TB-20-799

**RCRBD Record Set
T.A.**

A NEW PLAN FOR THE
HOME RANCH
27315 HOME RANCH ROAD
ROUTT COUNTY, COLORADO

COLUMBINE CABIN

S-1.3

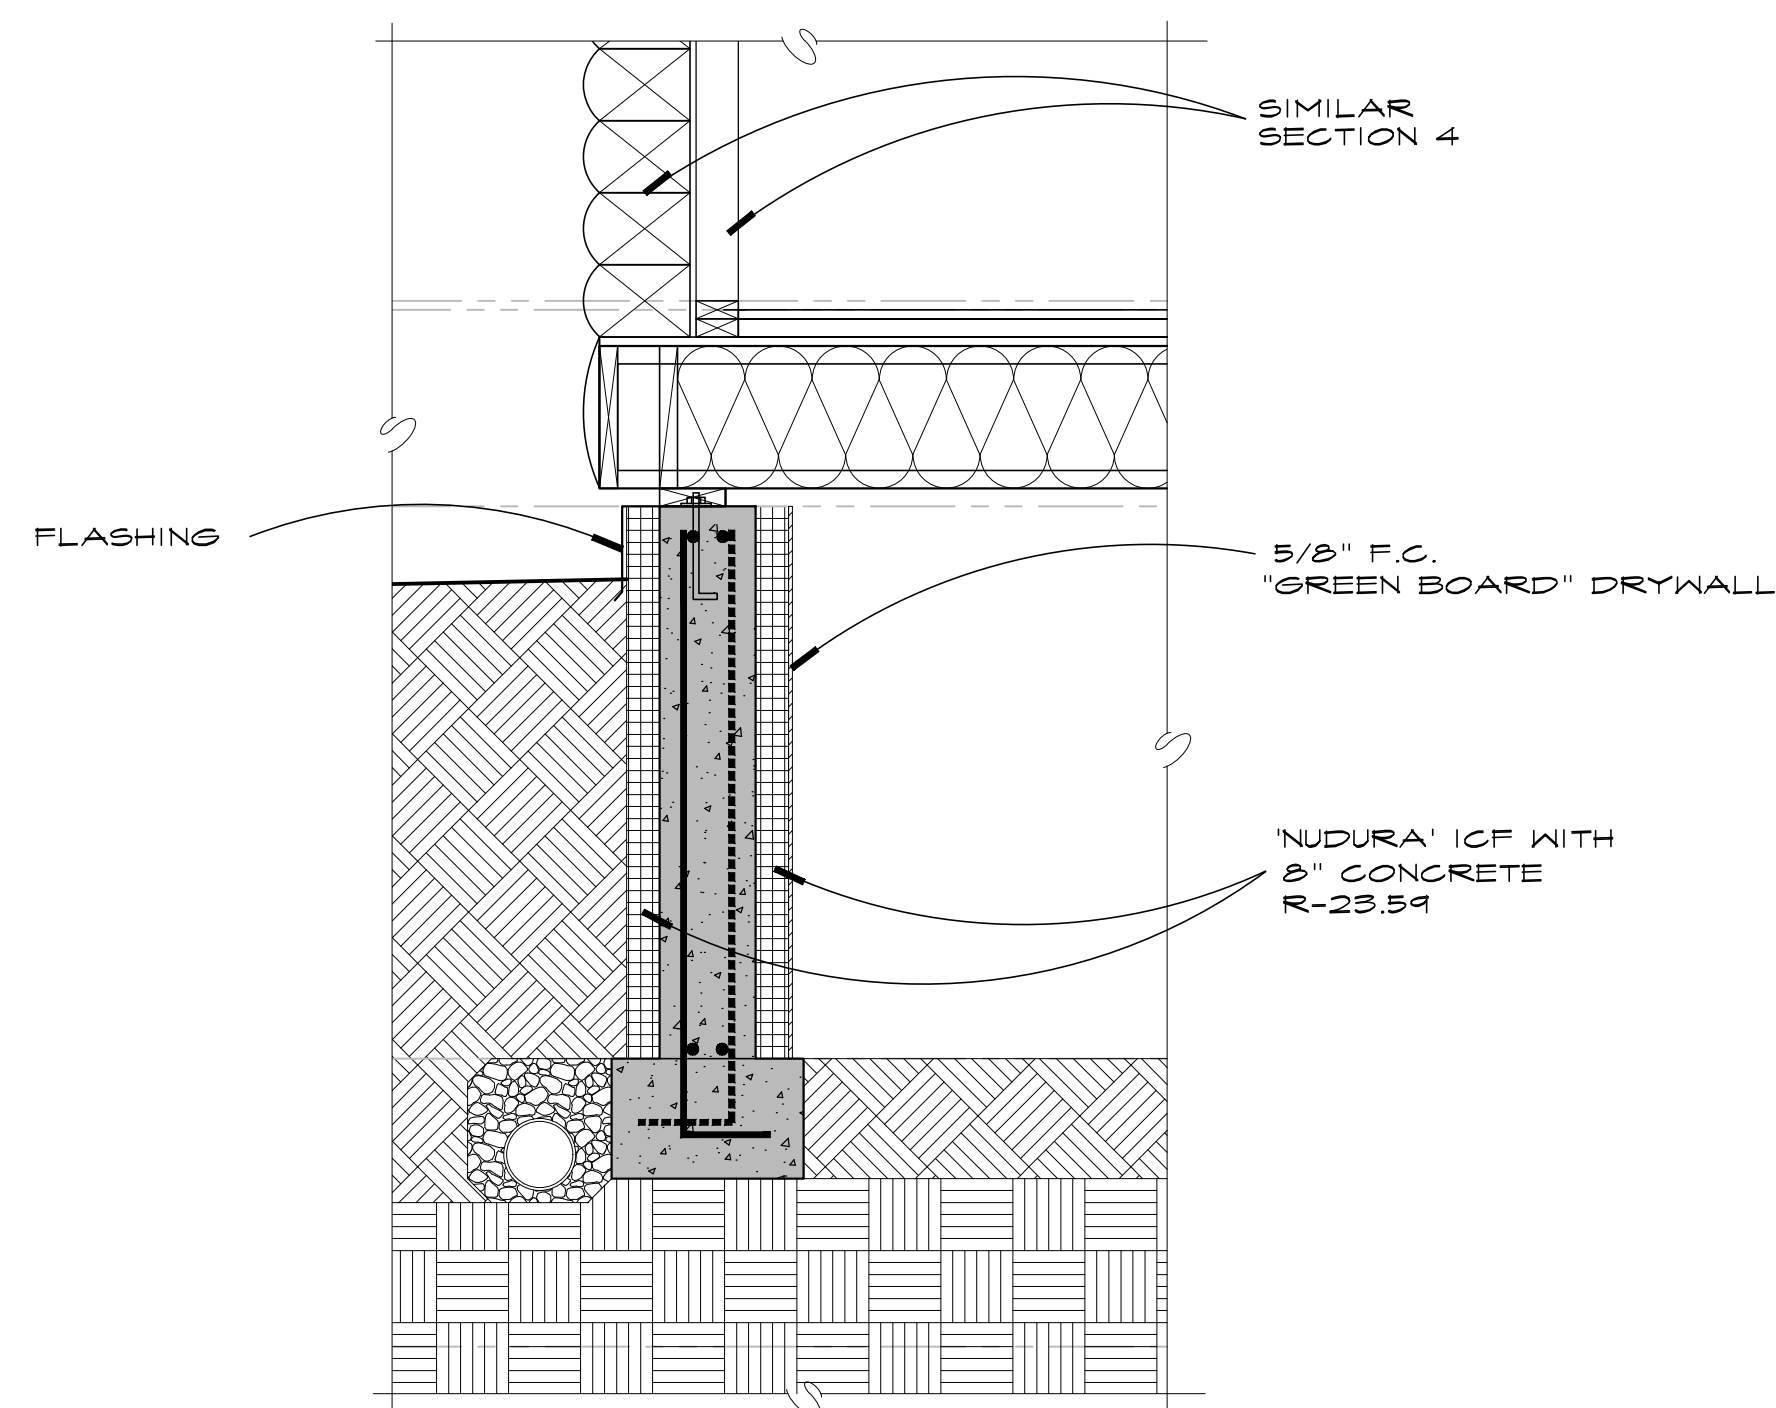
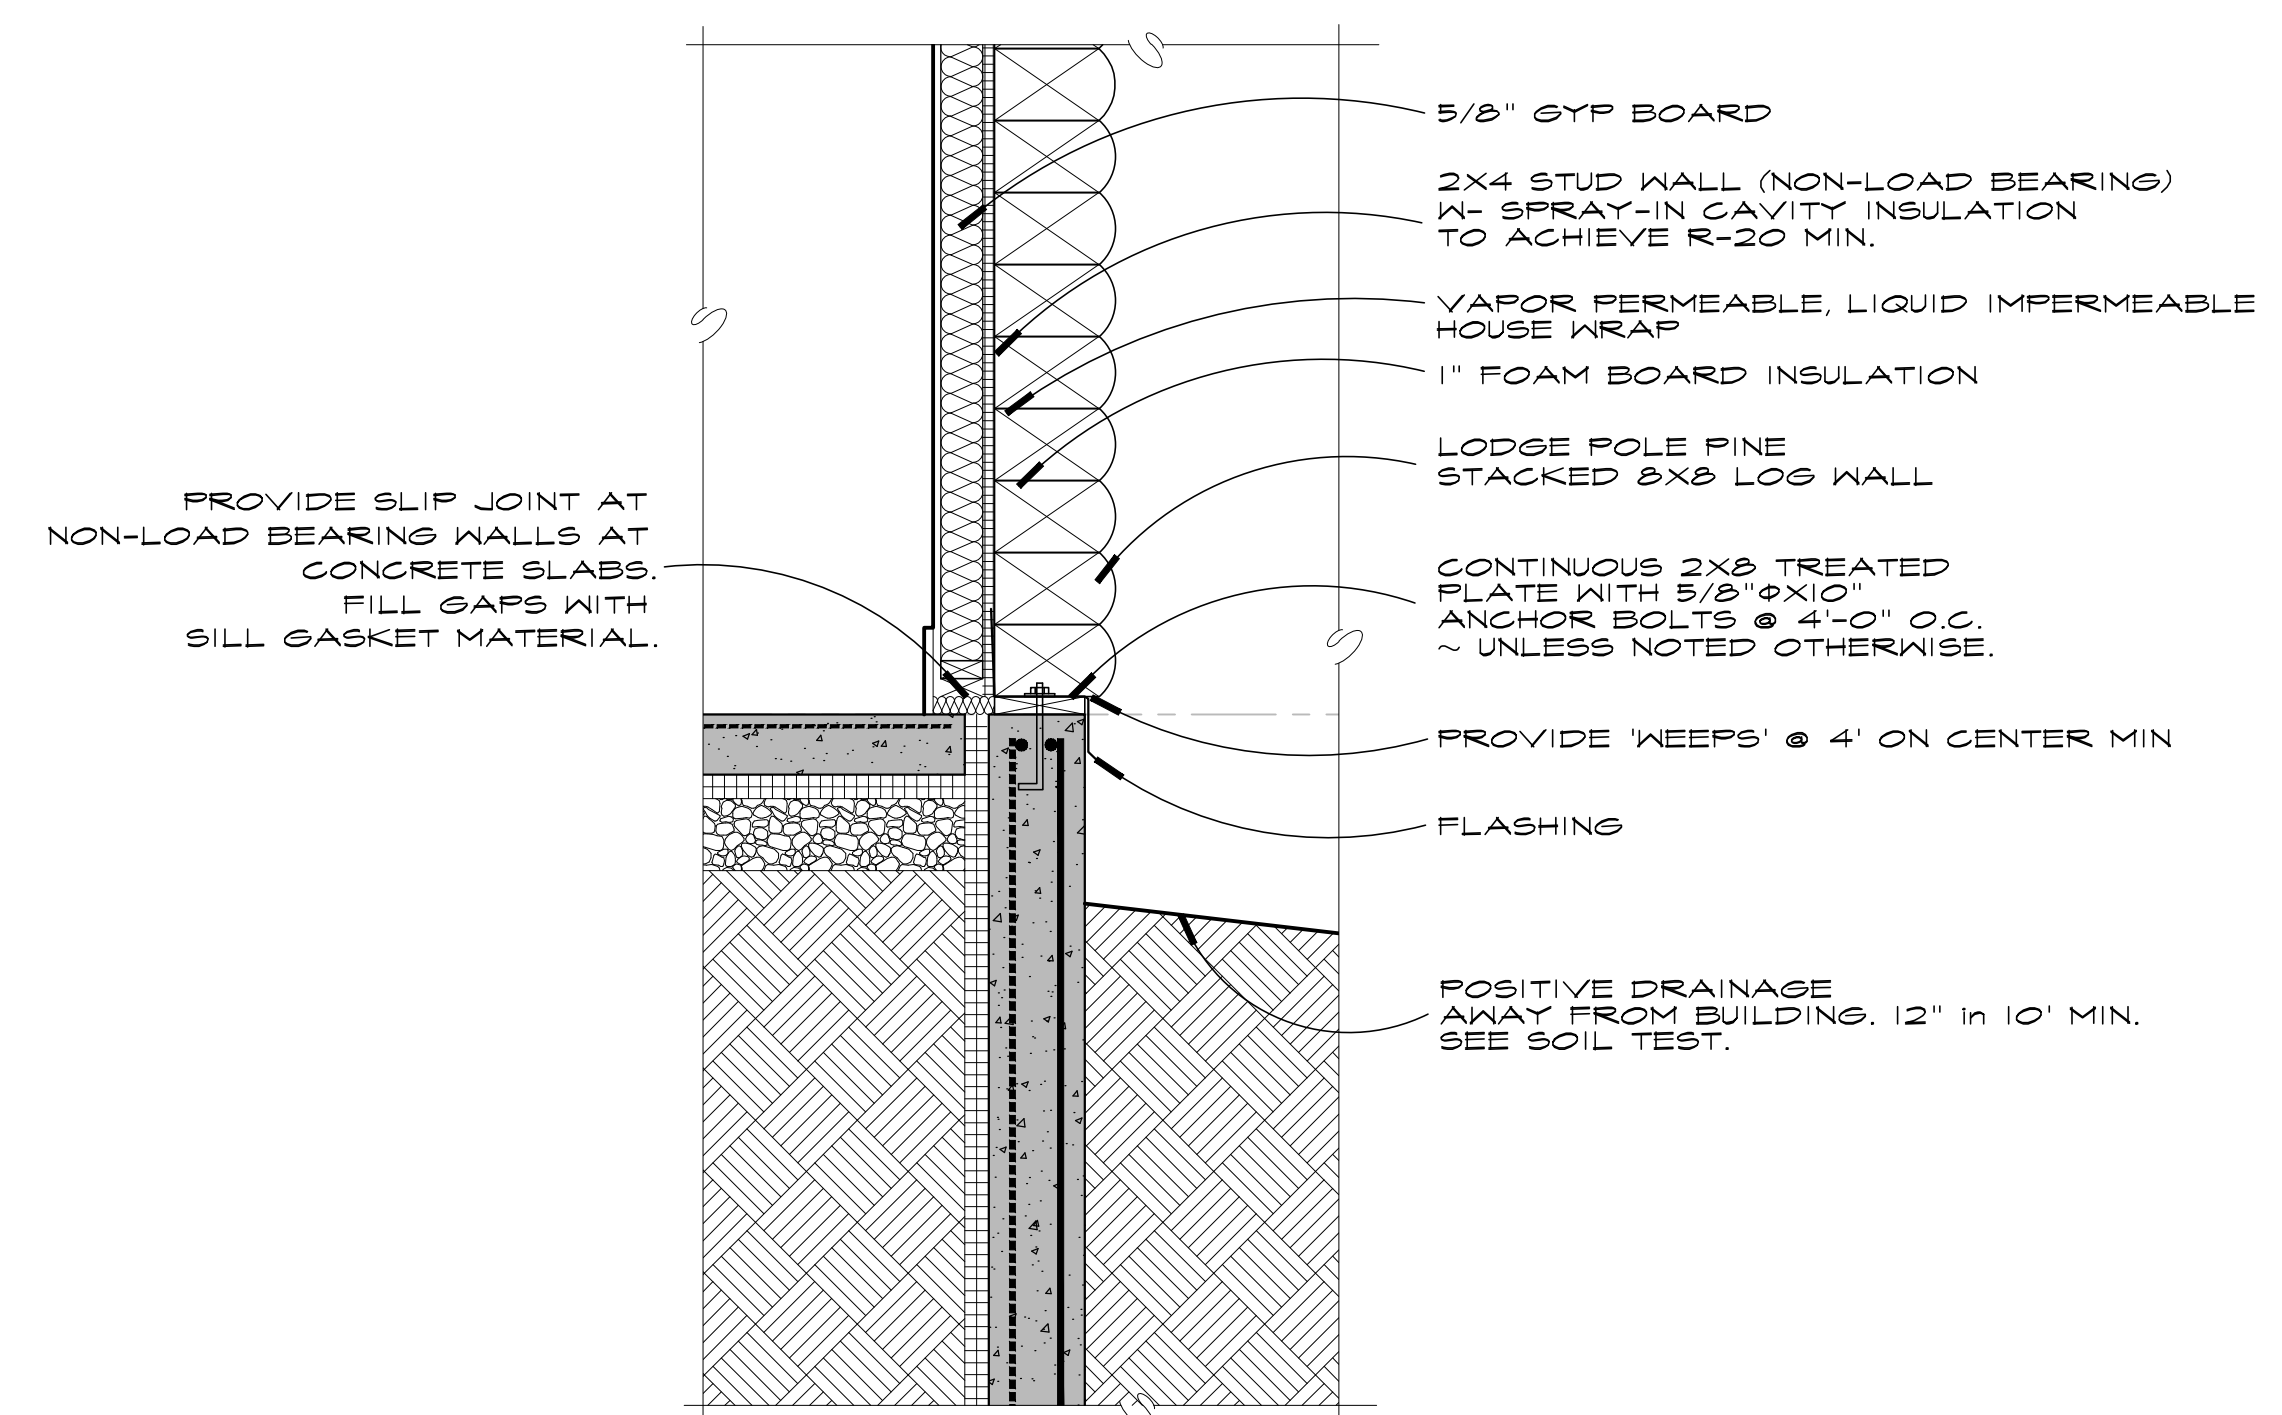
1. This project is in the concurrent review process with the other Departments. Review comments in Viewpermit, as applicable, when available.
2. The insulation value of walls provided under paragraph B of DIVISION 7 - THERMAL AND MOISTURE PROTECTION shows R-21 while the Table PRESCRIPTIVE PATH METHOD TO BE USED FOR I.E.C.C. COMPLIANCE provides the correct R-20 +5 continuous. Please show how this is installed in the wall and show how the conditioned crawl space is insulated.

SECTION 5 TYPICAL AT NEW CRAWL SPACE

SECTION 4 TYPICAL AT NEW STACKED LOG WALLS

We are submitting additional sheet number S-1.3 to clarify insulation requirements for the Columbine Cabin addition as requested in your plan review comments.
